EXHIBIT JJ

Re: Requested modifications to The Views PD Conditions (File No. 20-028)

Re: File No. 20-028, The Views Planned Development - Approval Criteria and Supplemental Materials

Re: File No. 20-028, The Views Staff Report Questions

CUL-DE-SAC DRIVEWAY ANALYSIS

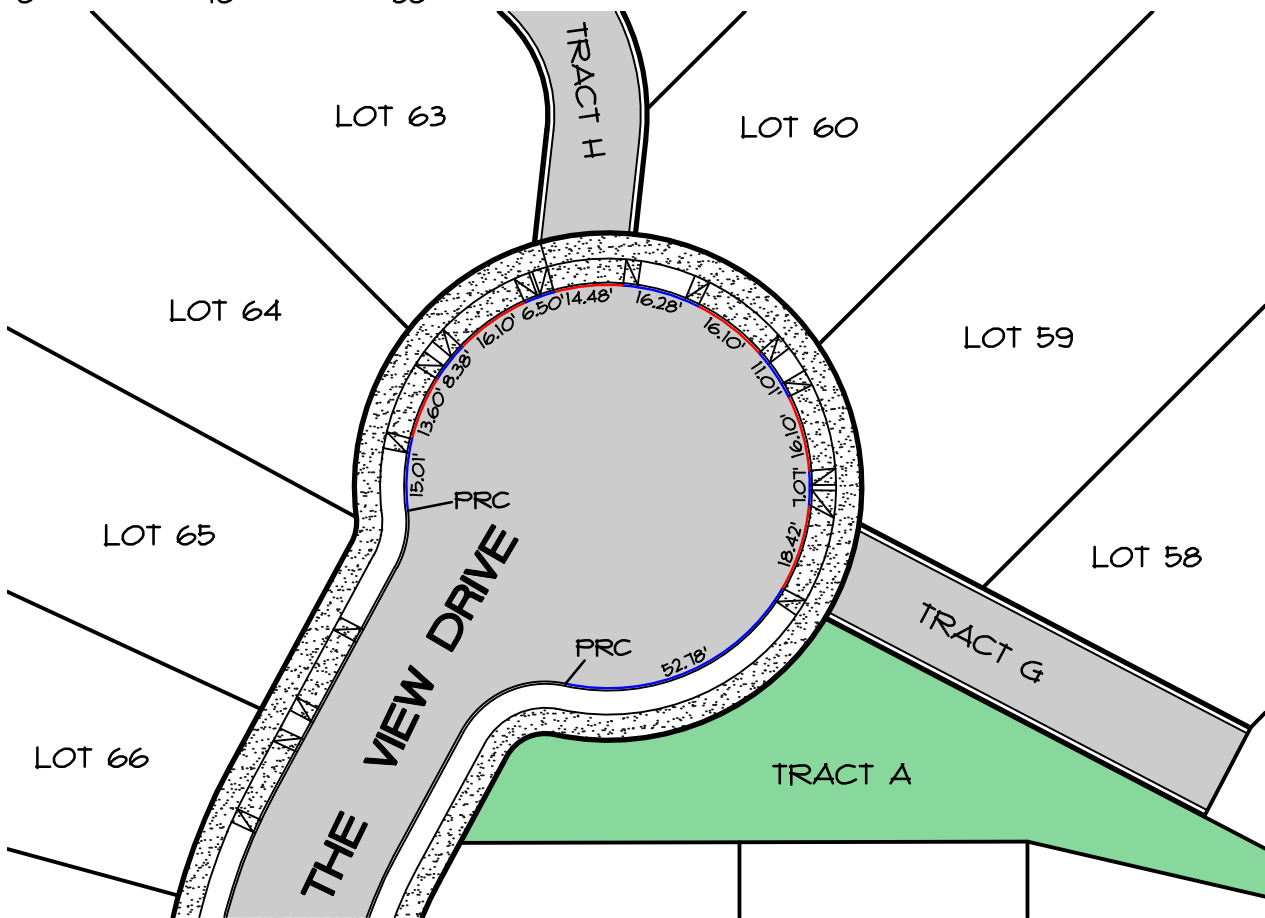
curb transition. Shared driveway approaches may be required for adjacent lots in cul-de-sacs in order to maximize room for street trees and minimize conflicts with utility facilities (power and telecom pedestals, fire hydrants, streetlights, meter boxes, etc.). **The applicant shall update the driveway plan to detail shared driveways for the following pairs of Lots: 43 and 44, 45 and 46, 59 and 60, and 63 and 64.** As shown on the applicant's submittal, allowing each cul-de-sac lot to be accessed by a separate driveway complies with the intent of this section.

Response: The applicant requests this Condition be modified to allow lots accessed from a cul-de-sac to have their own driveway rather than a shared driveway. The reason for this request is these are the premium lots in the development, likely to contain three car garages and RV parking. A shared driveway configuration makes maneuvering in and out of these lots more challenging and detracts from the benefit of having a large lot. As shown on the sketch below, the proposal for individual driveways provides an opportunity to plant three trees within the cul-de-sac. In addition, as the attachment below shows, the sum of the width of all driveway approaches in the two proposed cul-de-sacs do not exceed 50 percent as required.
